E5052B-04**S E R V I C E N O T E**Supersedes:
NONE**E5052B Signal Source Analyzer****Serial Numbers: MY47201115 to MY47201421, SG47200134 to SG47200137****Automatically shut down after a few seconds beeping occurs when user turns on the instrument****Parts Required:**

Situation:

Automatically shut down after a few seconds beeping occurs when user turns on the instrument.
This is due to CPU Fan rotor dropped off or CPLD on CPU board is broken.

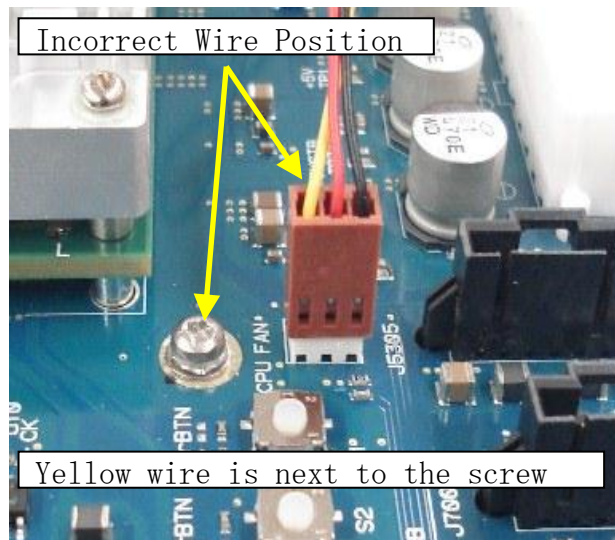
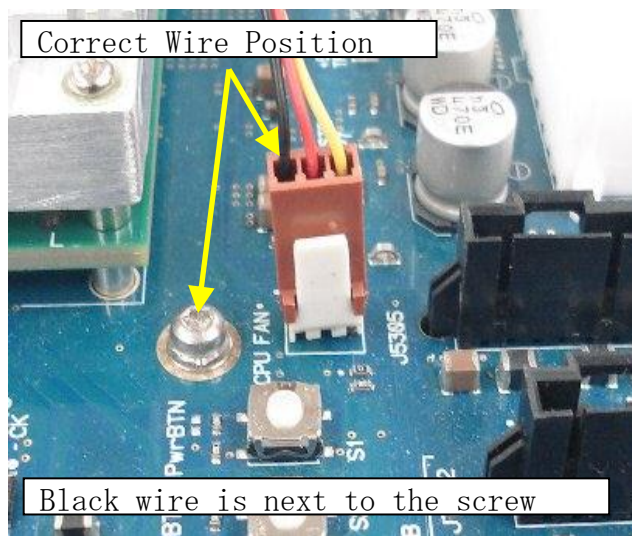
1. Push down CPU fan's rotor using something like tooth pick just after turning on power switch.

2. If CPU fan rotates, then the cause of the trouble is [dropped off rotor]

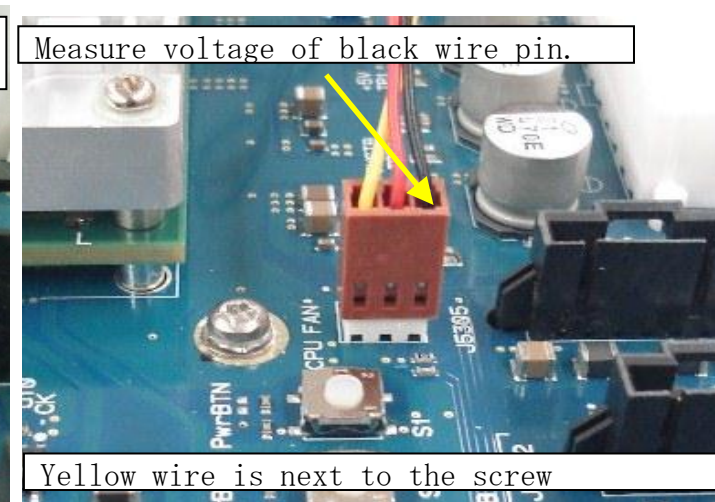
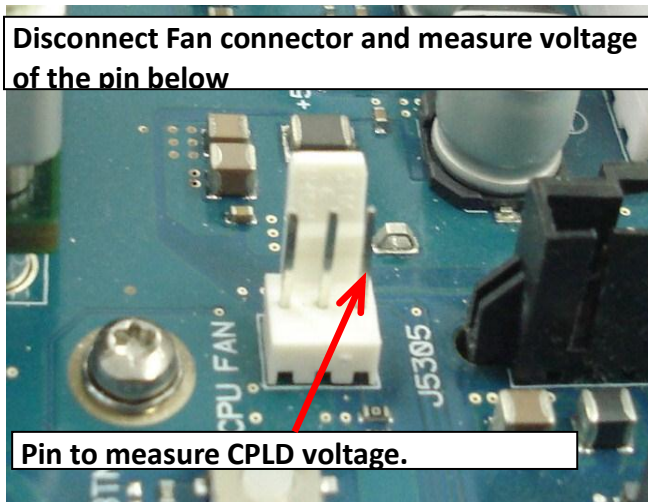
2-1. Check whether connector post (J19) for the CPU fan's interface cable is the correct direction or the opposite (incorrect) direction as shown below.

2-2. If black wire of the CPU fan cable is next to the nearby screw, J19 is assembled in a correct way. In this case, just replace CPU fan with a new one (3160-4452) for repair.

2-3. If yellow wire of the CPU fan cable is next to the nearby screw, J19 is assembled in an incorrect way. In this case, disconnect the CPU fan cable from J19 and measure CPLD voltage of the pin

2-3-1. If the voltage is less than 1.2V, CPLD circuit of the CPU carrier board is damaged. In this case, replace whole CPU assembly with E5070-62060.

2-3-2. If the voltage is greater than 1.5V, the circuit of the CPU carrier board is OK. In this case, replace CPU fan and interface cable with 3160-4452 and E5071-61680.
